## Product Change Notice (PCN)

**PCN Number:** PCN-0451129R-01

Product(s) Affected: *PJ-031D & PJ-031DH*

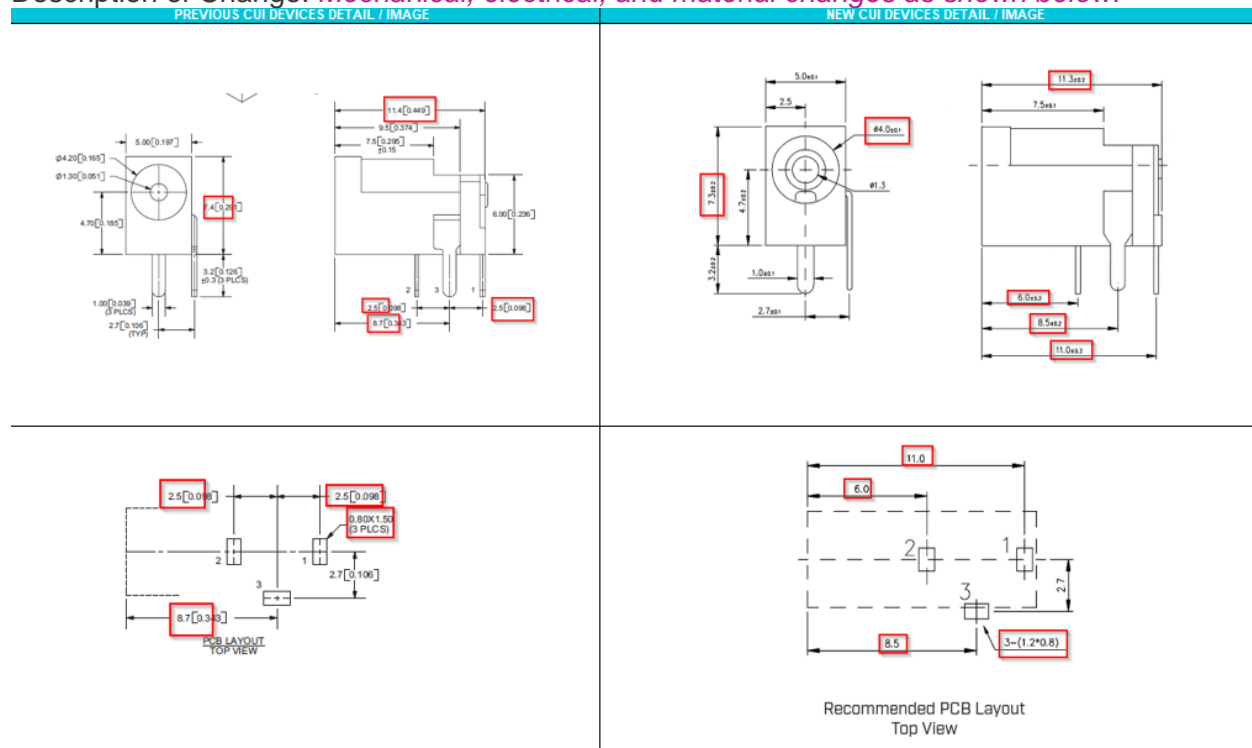
Description of Change: *Mechanical, electrical, and material changes as shown below:*

MATERIAL	PLATING
center pin	copper	nickel
terminal 1	brass	silver
terminal 2	copper alloy	silver
terminal 3	brass	silver
plastic	PBT

DESCRIPTION	MATERIAL	PLATING/COLOR
center pin	brass	silver
terminal 1	brass t=0.50	silver
terminal 2	MM alloy t=0.20	silver
terminal 3	brass t=0.50	silver
housing	PA10T (UL94V-0)	black
